September 26, 2025

ADDENDUM NO. 2

DNR-250004 GREAT COUNCIL OBSERVATION TOWER

G4

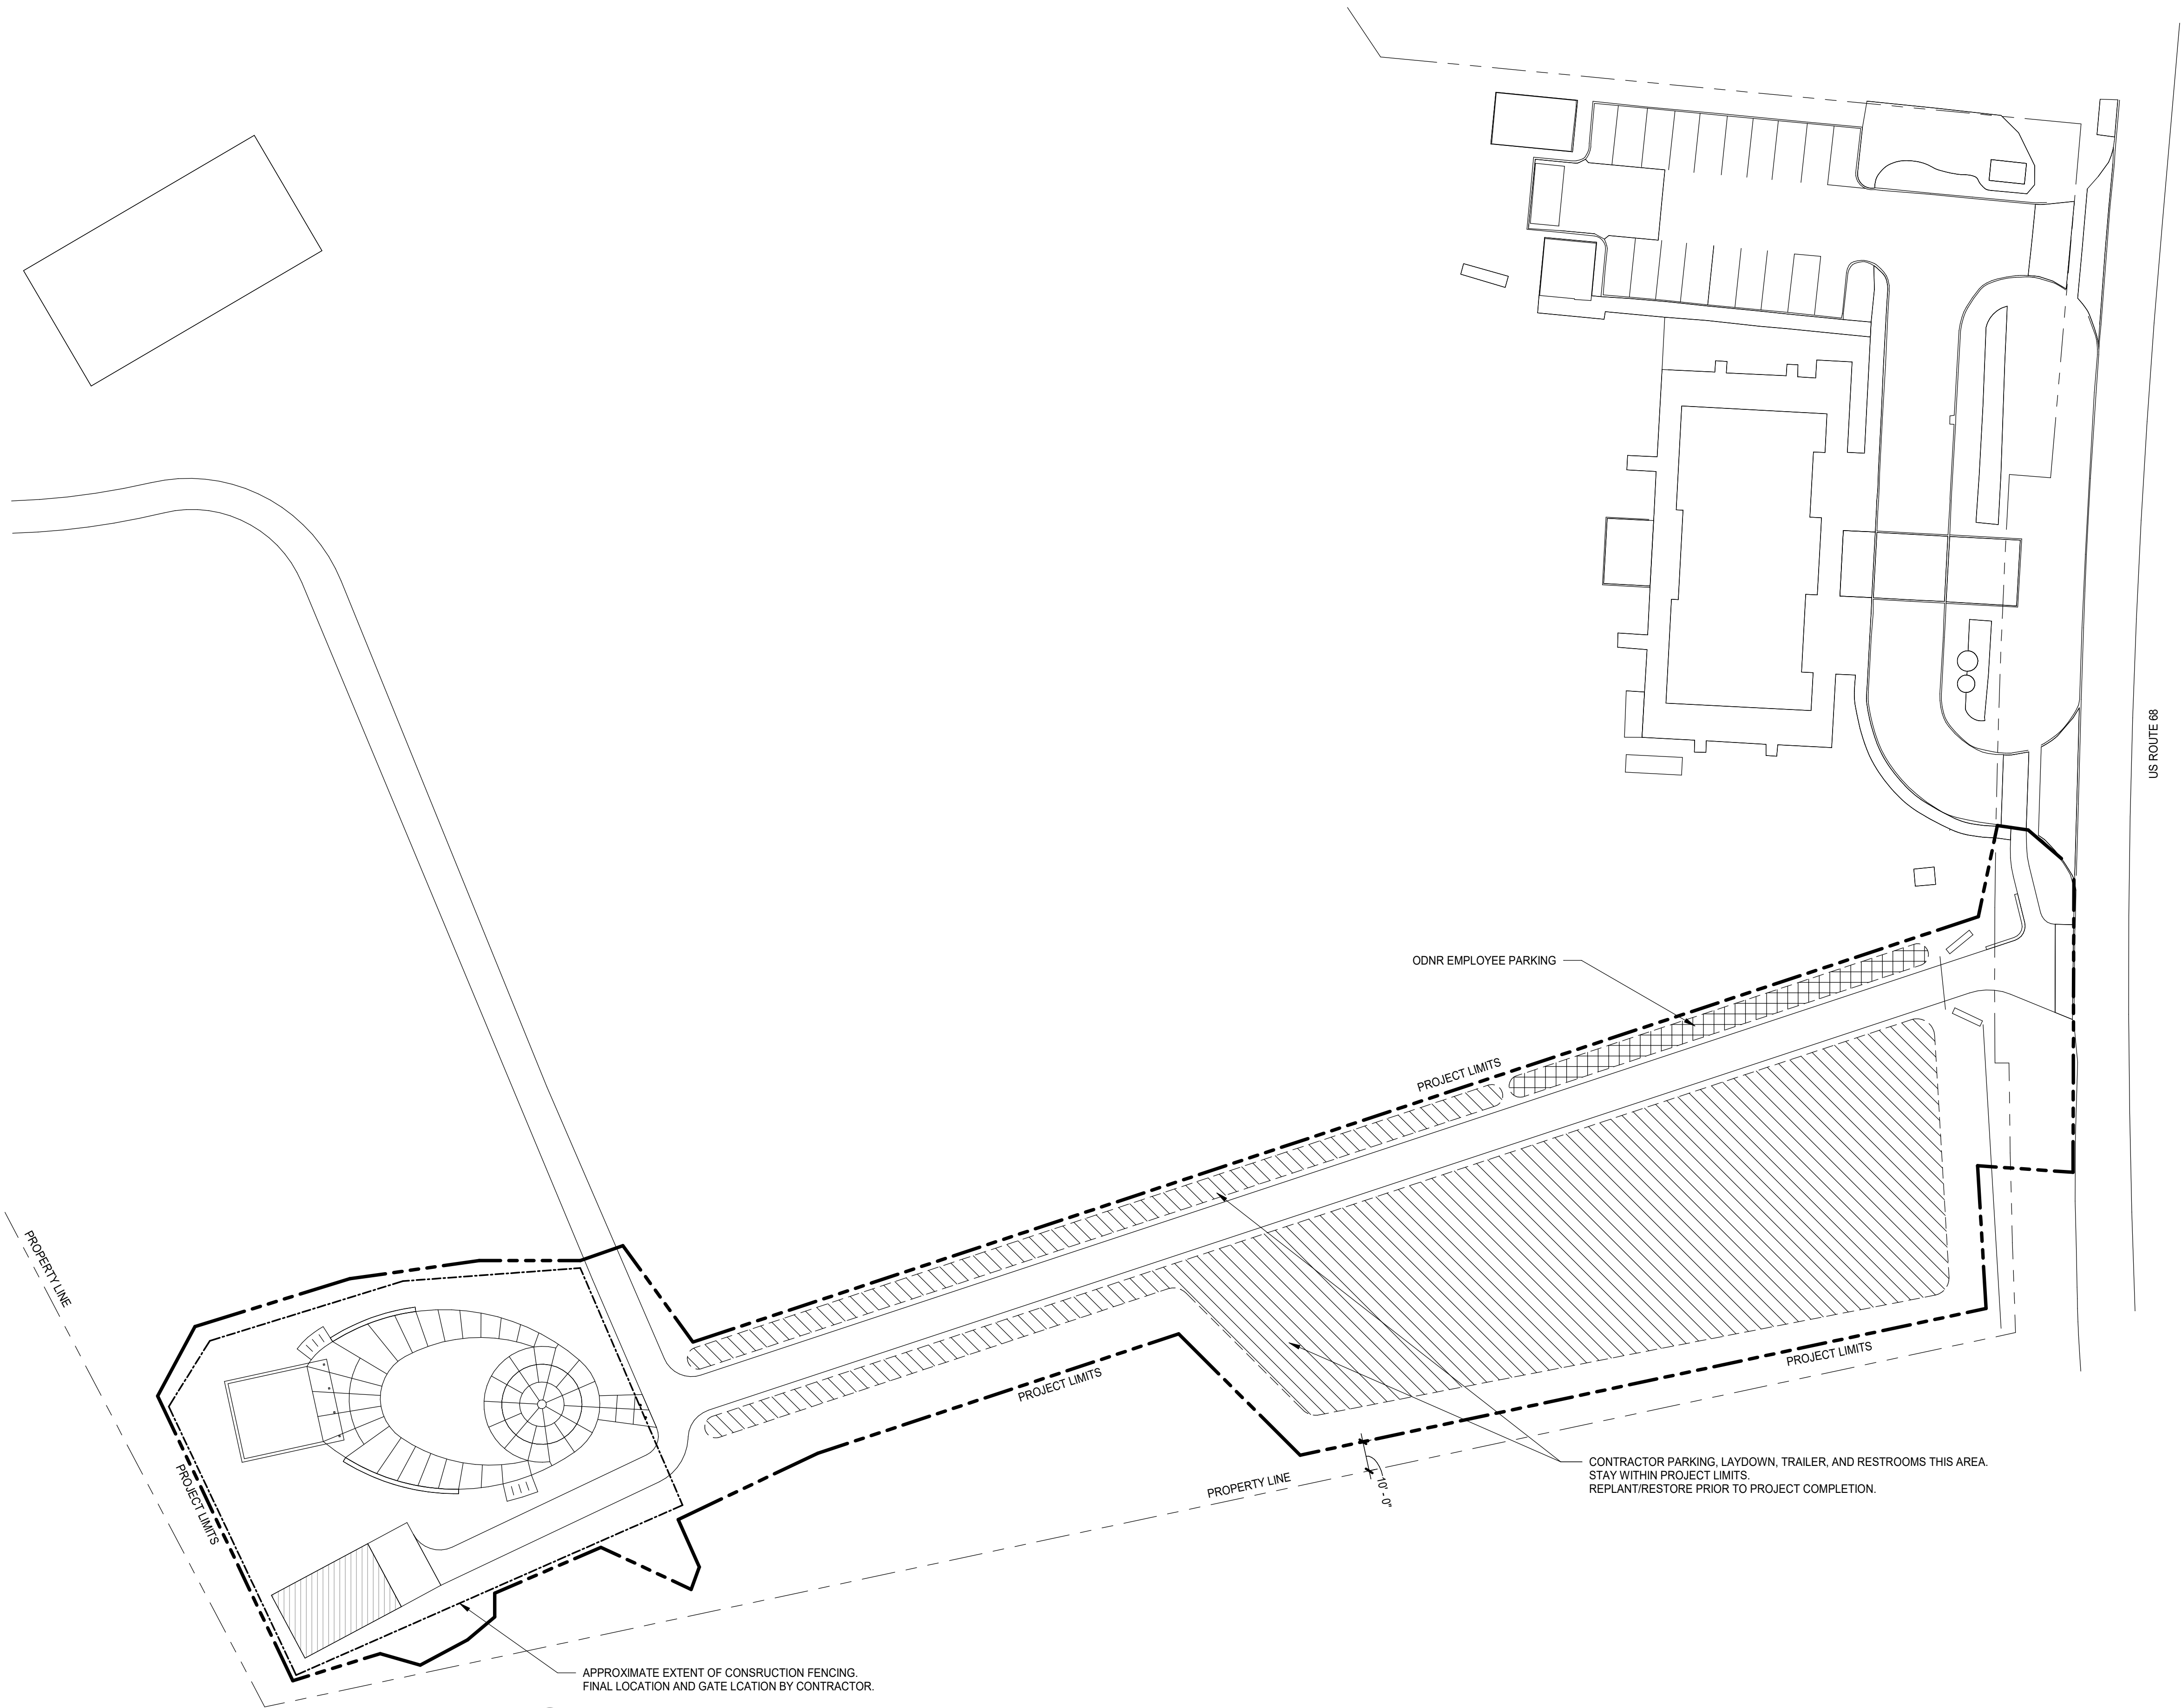
ITEM 4 G4 – SITE LOGISTICS PLAN

Added sheet to project.

C100

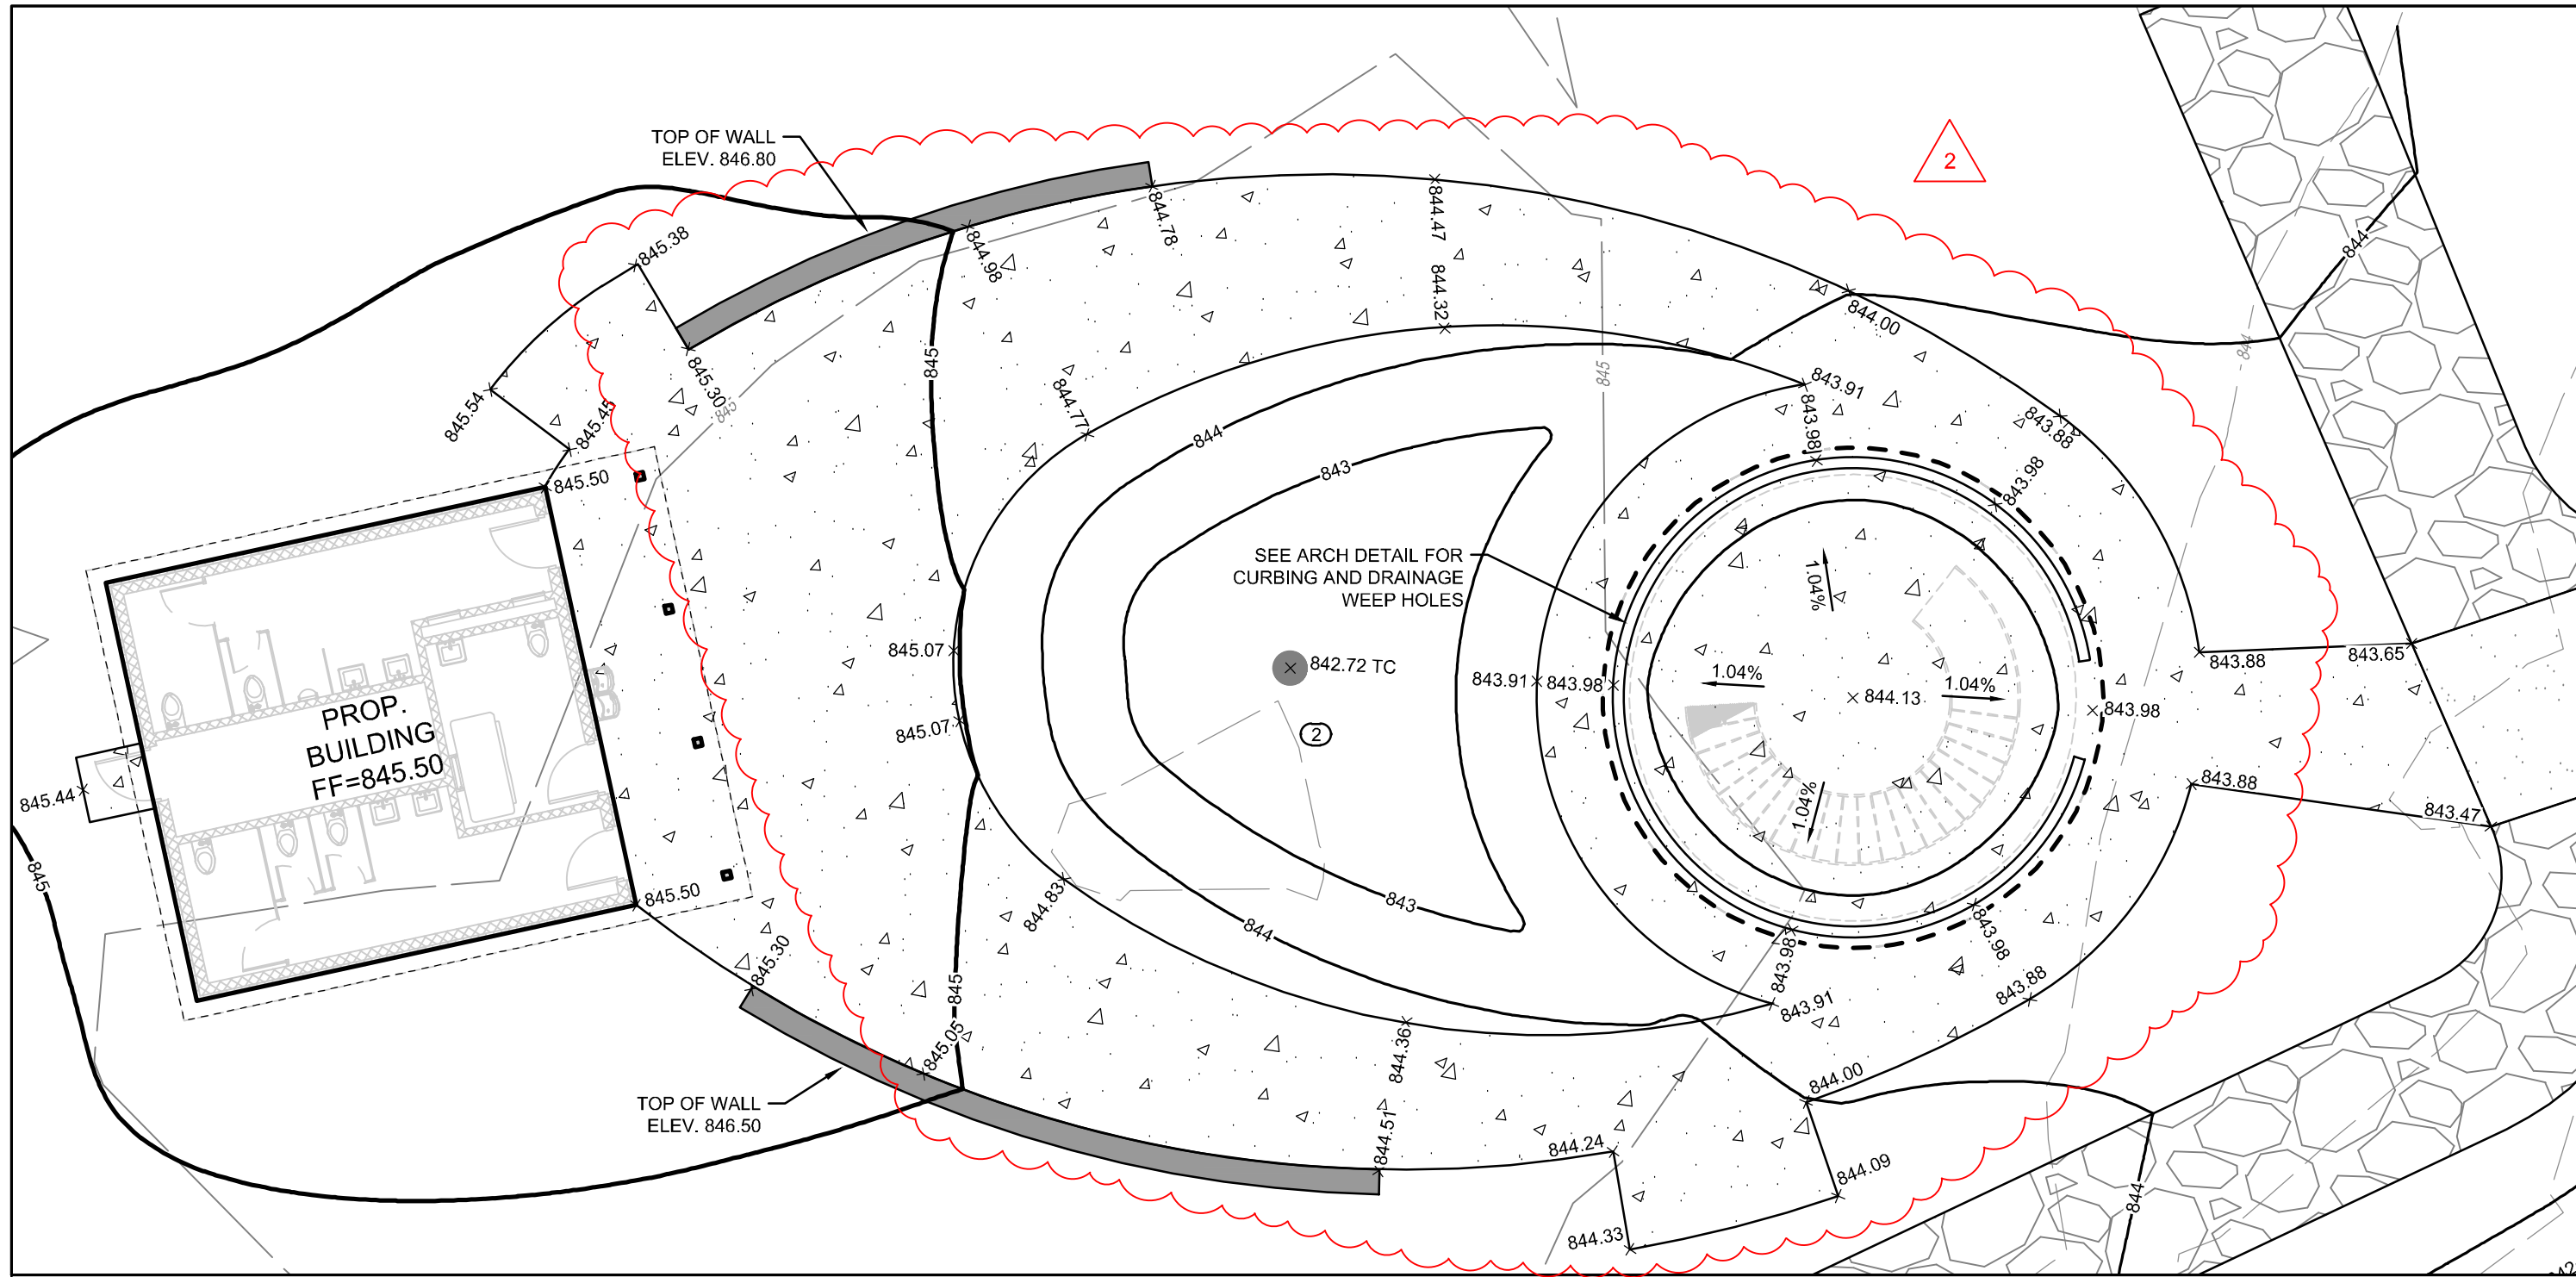
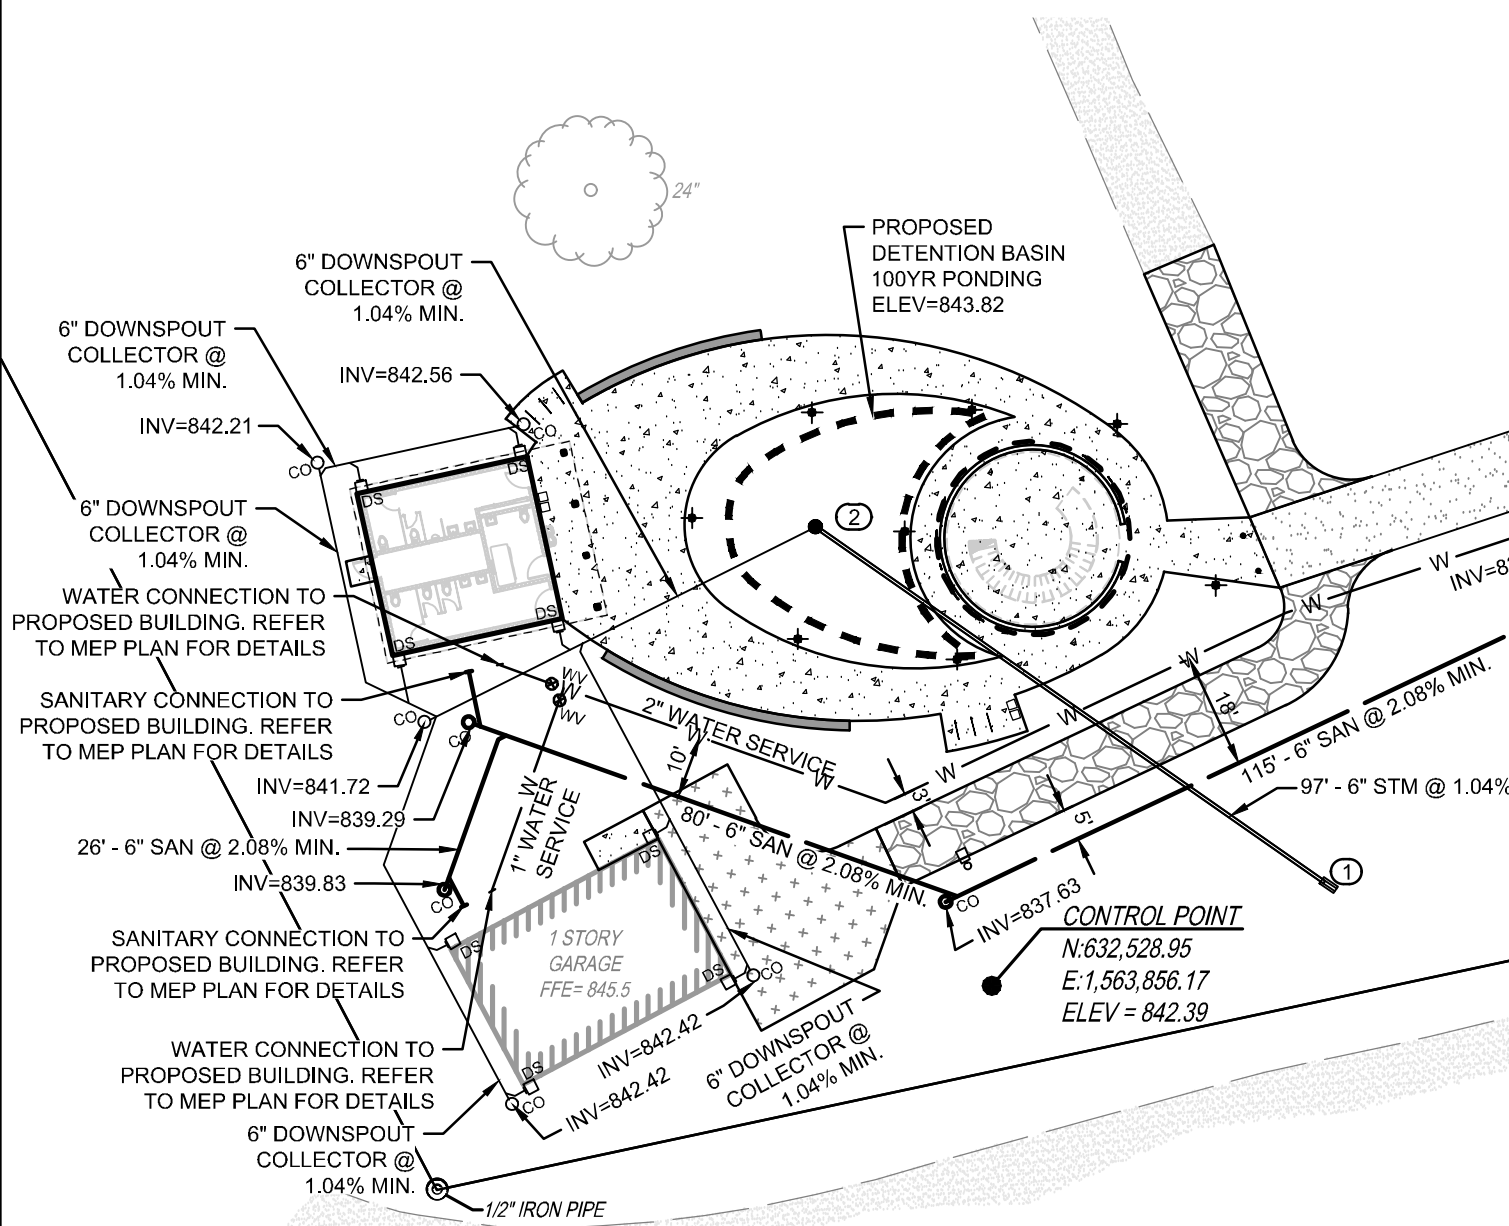
ITEM 5 C100 – UTILITY PLAN

Added note regarding hand digging around existing tree at water meter enclosure.
